SERVICE INFORMATION
Bulletin Nbr: 844-1784 UTG. 2
Date:.....NOVEMBER 1998
Market: ALL

Internal Front Door Window Seal is Coming Loose

D843B001

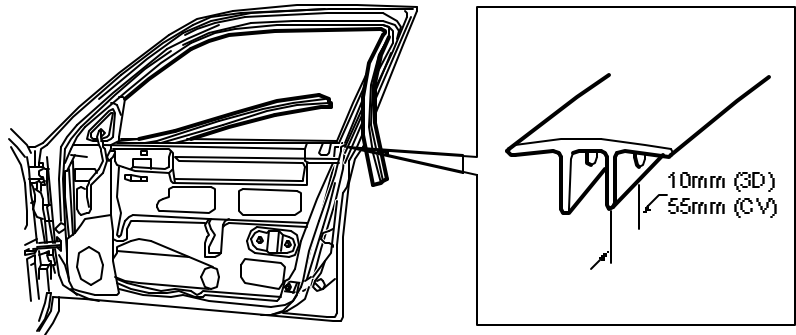
The internal window seal on some cars can lift up a few mm at the rear edge. Follow the directions below to rectify this complaint.

Protect the window from drilling damage by putting a putty knife (or something similar) between the internal window seal and the window.

3. Drill a 2 mm hole approximately 10 mm (on 3-door) or approximately 55 mm (on Convertible) from the rear of the internal window seal.

Drill through both seal and flange.

4. Secure the seal with a screw, part number 79 75 535.
5. Refit the door panel.
